### **3.0 Site-Specific ITAAC**

Table 3.0-1 ~~Table 9.3-4~~ Ultimate Heat Sink (UHS)

Figure 3.0-1 ~~Figure 9.3-1~~ UHS and Reactor Service Water System

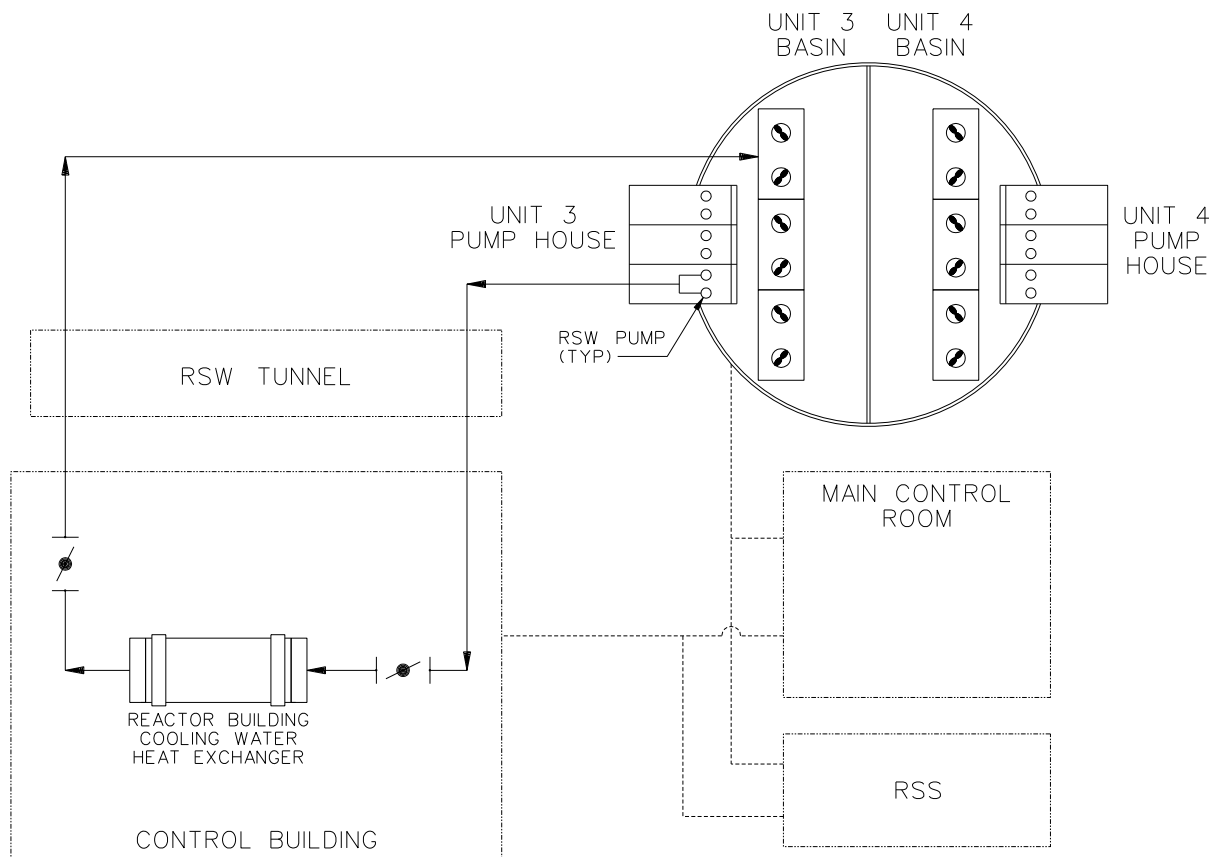
Design Requirement	Inspections, Tests, Analyses	Acceptance Criteria
1. The basic configuration of the UHS is as shown on Figure <del>9.3-4</del> 3.0-1.	1. Inspections of the as-built system will be conducted.	1. The as-built UHS conforms with the basic configuration shown on Figure <del>9.3-4</del> 3.0-1.

4. Displays and controls in the main control room and remote shutdown system (RSS) are provided for required functions of the UHS system.	4. Inspections will be performed on the main control room and RSS displays and controls for the UHS system.	4. Displays and controls exist in the main control room and as shown on Figure <del>9.3-4</del> 3.0-1.

Design Requirement	Inspections, Tests, Analyses	Acceptance Criteria
1. The basic configuration of the site-specific RSW is as shown on Figure <del>9.3-1</del> 3.0-1.	1. Inspections of the as-built system will be conducted.	1. The as-built RSW conforms with the basic configuration shown on Figure <del>9.3-1</del> 3.0-1.

5. Displays and controls in the main control room and RSS are provided for required functions of the RSW system.	5. Inspections will be performed on the main control room and RSS displays and controls for the RSW system.	5. Displays and controls exist in the main control room and RSS as shown on Figure <del>9.3-1</del> 3.0-1.
